HYDROLOGY L23/D5 NINE PLANS

Re: Orona Addition, Albuquerque, New Mexico

Re: Orona Addition
Lot Ponding Requirements

SUBJECT: ORONA SUBDIVISION

FRENCH DRAIN DETAIL
ORONA ADDITION
WEST SIDE OF STREET

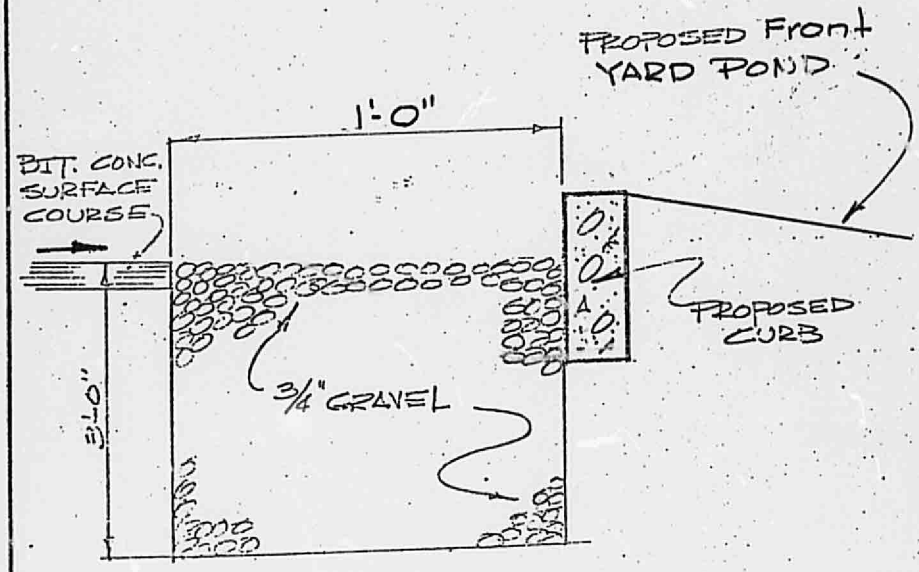
Due to the nature of the 4% slope from east to west it will be virtually impossible to grade and construct a uniform ponding system for all lots within the project. Therefore, it is recommended that 100 cubic feet of storage be provided within the lawn areas between the parking lot, building, and within the limits of the service walks. For those lots on the east side of the street, roofs, rear and side yard areas should be graded to drain to parking area. The parking area should then be back pitched to create an additional pond of 650 cubic feet adjacent to the wheelstop curb and adjacent french drain.

Those lots on the west side of the street should be graded such that the parking lot, roof, side and rear yards drain to a 650 cubic foot pond in the rear yard. This method will require the installation of precast concrete parking bumpers in lieu of curb to allow parking lot water to enter the ponds between building and parking lot.

FRENCH DRAIN DETAIL

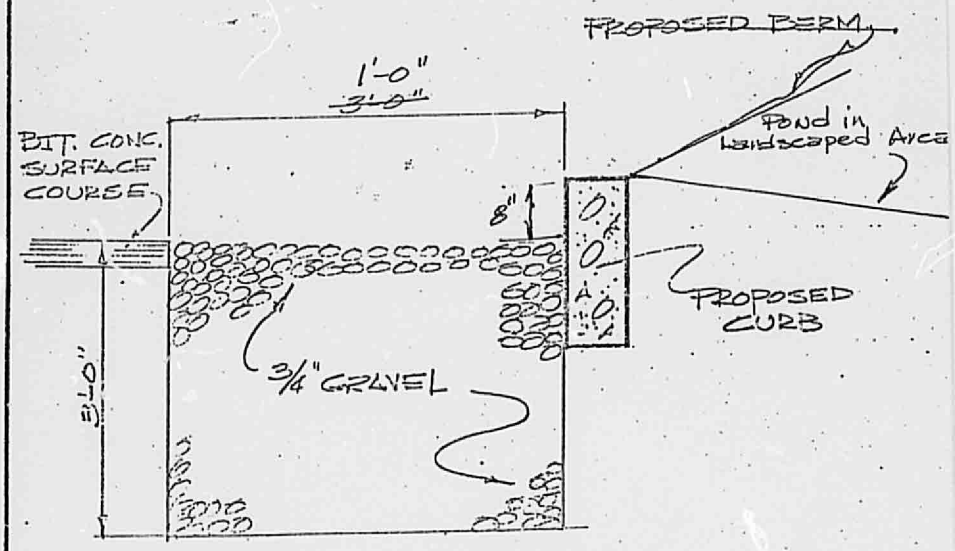
Lots on East side of streets only.
